February 26, 2016

02609 Version 3

HFL Poor Sound Quality or Static

Supersedes 15-051, Titled HFL Poor Sound Quality or Static, dated December 9, 2015, to revise the information highlighted in **yellow**.

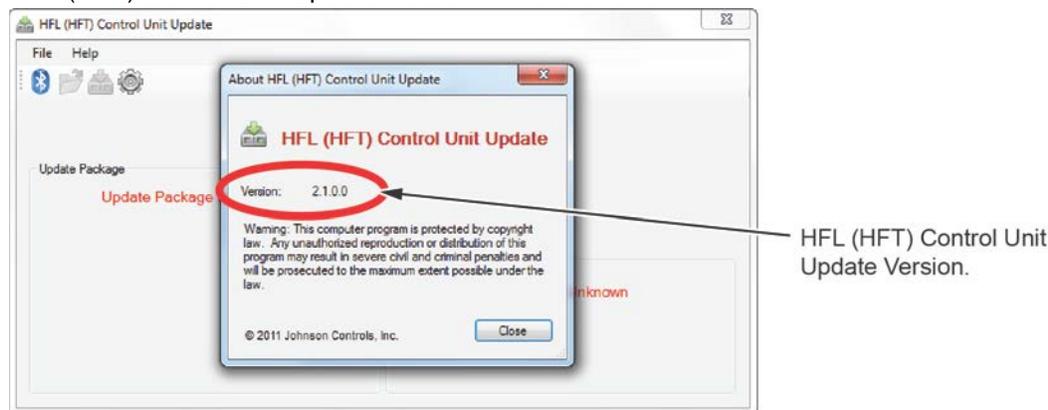
Cross-check the HFL part number and the HFL software version table in step 2 of REPAIR PROCEDURE to verify if the HFL control unit can be updated.

NOTE: Make sure there is a match between the HFL P/N and software version under SOFTWARE INFORMATION.
